ARKANSAS POWER & LIGHT COMPANY

ARKANSAS NUCLEAR ONE, UNIT 1

AMENDMENT TO FACILITY OPERATING LICENSE

Amendment No. 86
License No. DPR-51

FIGURE 4.18.1

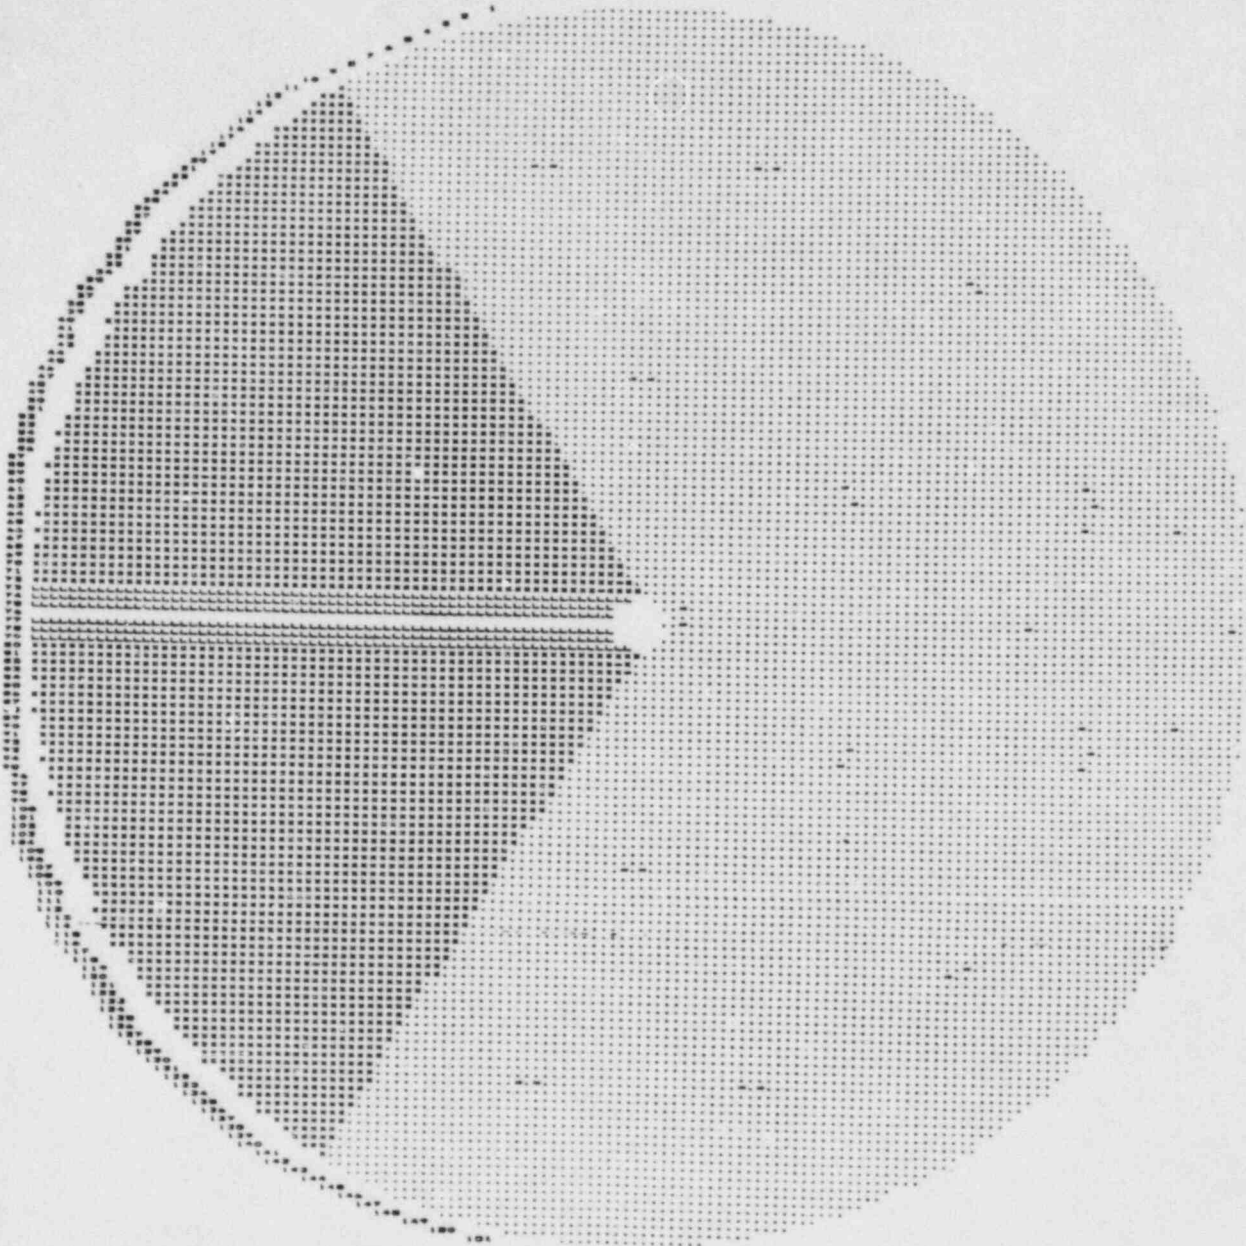
(3) Group A-3: Tubes in the wedge-shaped group on either side of the lane region (Group A-1) as defined by Figure 4.18.1.
